Consultation Response from KC, Highways Development Management
2024/91760 Land adj Healey Junior Infants and Nursery School, Healey Lane, Healey, Batley, WF17 8BN
Erection of 19 dwellinghouses with associated car parking, landscaping and boundary treatment and other associated works
Date Responded: 19/12/2024 Responding Officer: CNB Responding Ref: K13-1SE/26

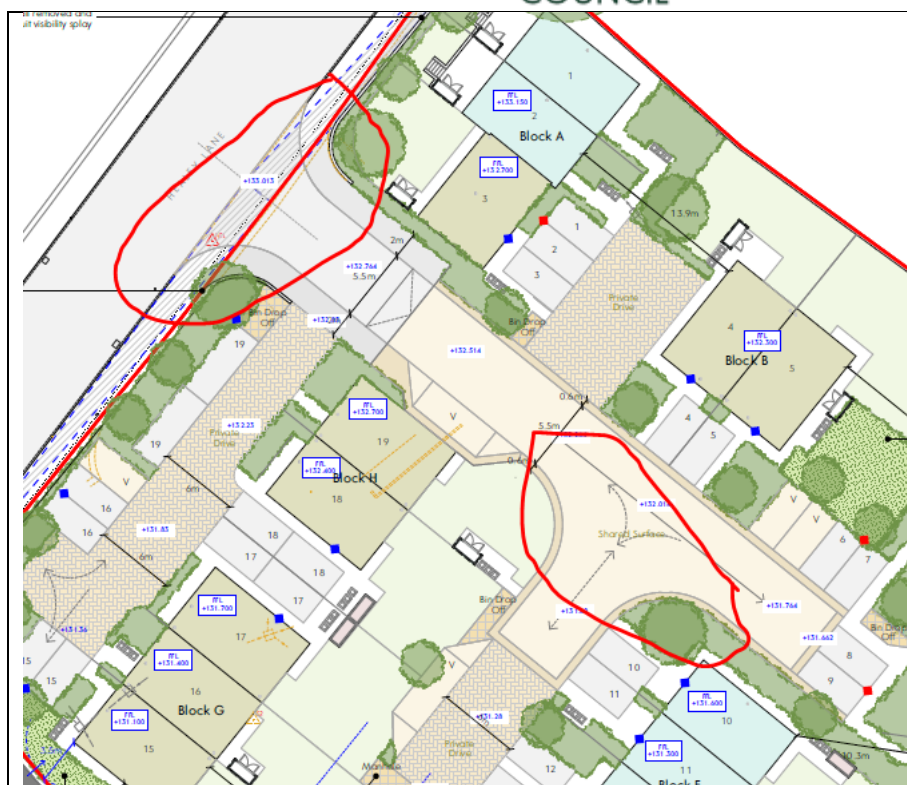
There are no other pedestrian access routes in to the site and for sustainability reasons we would like to see a pedestrian access on to West Park Road that would create a shorter route to bus stops. With just the proposed shared vehicular/pedestrian access the walking distance from the centre of the site to the closest eastbound stop is approximately 300m, with a pedestrian route directly on to West Park Road this could be reduced to approximately 165m. Westbound stops are slightly closer to the site. This would increase the attractiveness of public transport to residents on the site.

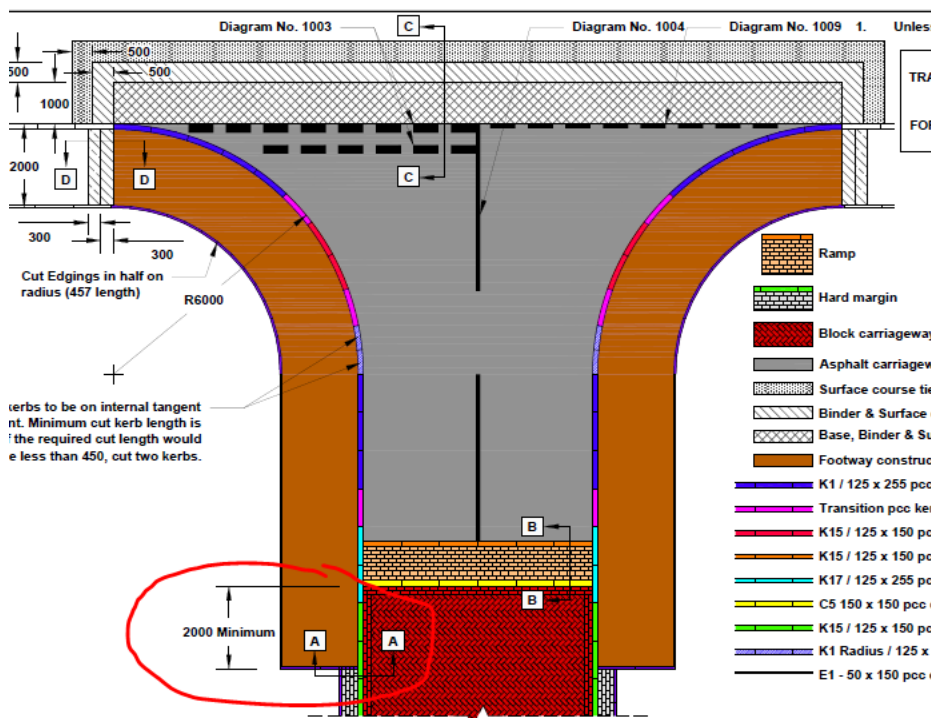
Where there is not a footway adjacent to the carriageway a minimum 5.5 metre wide shared surface (Type C) block paved carriageway with a minimum 600mm block paved margin on either side is required as per Table 1 and paragraph 3.14 of the Design Guide. Shared surface carriageway must not be steeper than 1:21 or 5% otherwise a Local Residential Street (Type B) with footways on both sides

will be required.
